**UNITED STATES  
NUCLEAR REGULATORY COMMISSION**

**SUBJECT: INDIAN POINT ENERGY CENTER UNIT 2 - NRC INSPECTION REPORT  
05000247/2004004**

Report No: 05000247/2004004

Facility: Indian Point Energy Center Unit 2

Figure 1 - SG Pressure

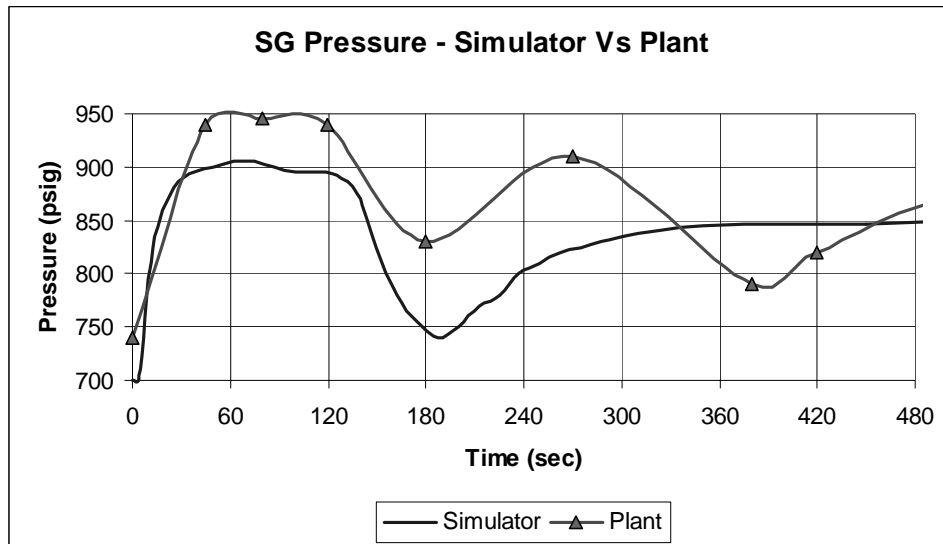
- (a) Steam generator pressure in the plant rose from 750 psi to 950 psi in the first minute of the event, then dropped to 830 psi before rising again. The simulator initially rose from 700 psi to 900 psi then decreased to 740 psi. See Figure 1 below.

Figure 2 - Cold Leg Temperature

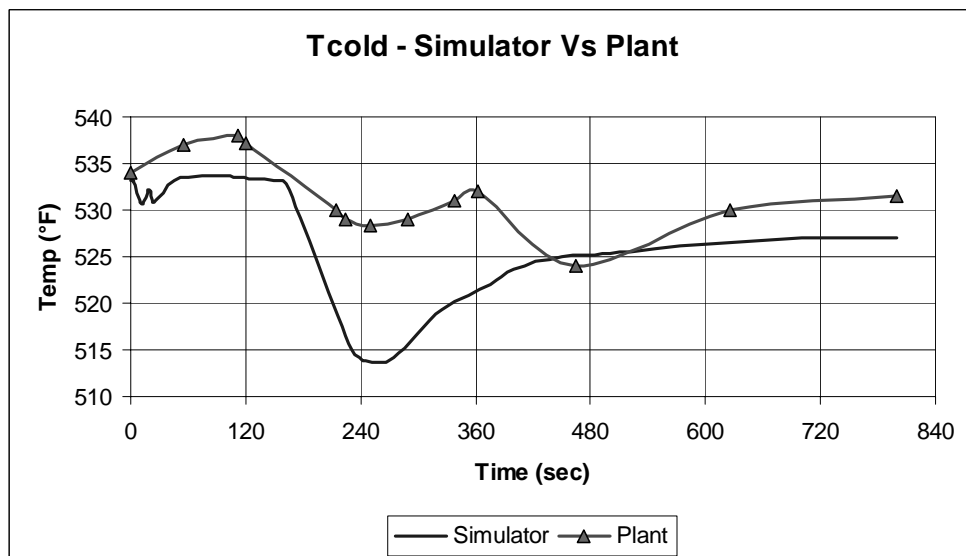
- (b) Loop  $T_{\text{cold}}$  instruments on the simulator showed an initial decrease of  $2^{\circ}\text{F}$  over the first twenty seconds of the event, followed by a return to the initial  $T_{\text{cold}}$  of  $534^{\circ}\text{F}$ . At approximately two and a half minutes into the event,  $T_{\text{cold}}$  decreased  $20^{\circ}\text{F}$  to  $513^{\circ}\text{F}$ . The reference plant showed an immediate, but gradual increase in  $T_{\text{cold}}$  following event initiation, raising  $T_{\text{cold}}$  from  $534^{\circ}\text{F}$  to  $538^{\circ}\text{F}$  over the first two minutes of the event. For the first 15 minutes of the event, the lowest temperature recorded in the plant was approximately  $523^{\circ}\text{F}$  while the simulator's lowest temperature was approximately  $513^{\circ}\text{F}$ . See Figure 2 below.

**Figure 3 - Reactor Coolant System Pressure**  
(from three consecutive annual simulator transient tests)

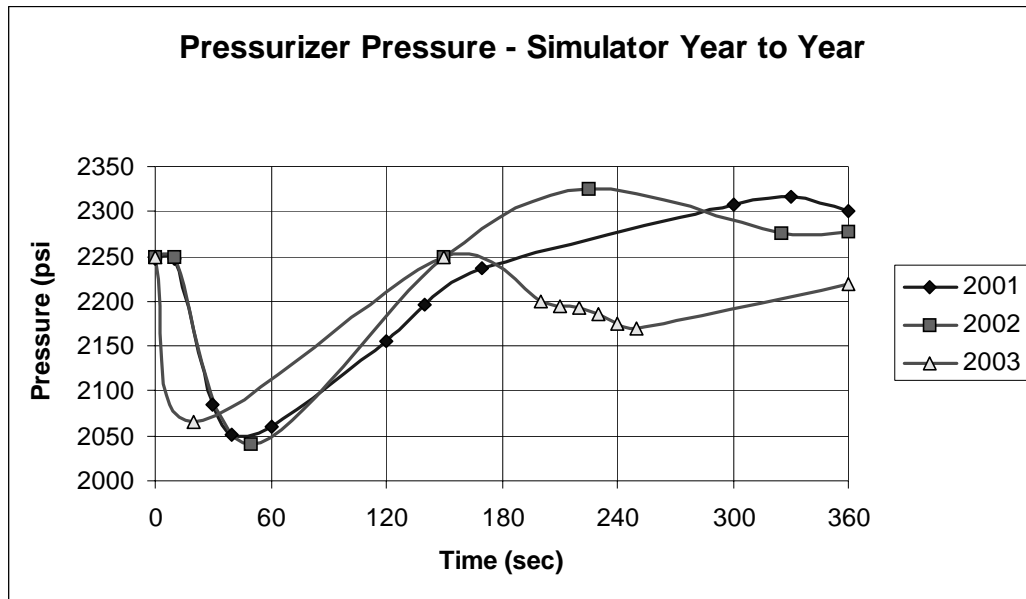
The ANSI/ANS 3.5-1985 standard requires that the observable change in parameters correspond in direction to those expected from a best estimate for the simulated transient. Contrary to this standard, test data showed observable changes in parameters that do not correspond in direction to those of the same parameter in data used as the comparison reference. Relative magnitude of parameter response is also different in some instances from the comparison reference.

An example of an undocumented difference in trend data from a simulator transient test in one year to the same simulator transient test performed in the previous years is illustrated graphically in Figure 3 below. This figure compares the Reactor Coolant System (RCS) pressure graphs for the simultaneous trip of all RCPs in calendar years 2001, 2002 and 2003. The figure showed a different simulated pressure response in each case with no documentation to explain the differences. The figure is a graph of RCS pressure in psi (vertical axis) versus time in seconds (horizontal axis). Note that this figure reflects a comparison of simulator to simulator data, rather than to reference plant data.
